SIB 36 02 22

DIGITAL TIRE DIAGNOSIS: DISCONTINUATION OF QR CODE ON PIRELLI TIRE SIDEWALLS

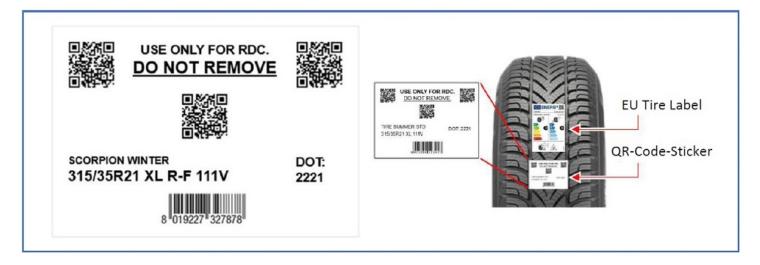
Starting mid-May 2022, the QR code on the tire sidewalls of Pirelli tires has been omitted due to patent reasons.

Instead of the QR code, Pirelli tires will be equipped with a QR code sticker so that the RDC programming can still be ensured. Example picture of the QR code sticker below:

Note that only Pirelli tires will have the QR code sticker. All other tire brands will keep the QR code on the tire sidewall until further notice. Continue to follow the normal RDC Programming procedure with tires that have a QR code sticker. The only change is the positioning of the QR code (on the sticker and not on the sidewall).

NOTE: Remove all stickers on the tire only after the programming of the RDC, to make sure the QR code is available when using the RDC tool.
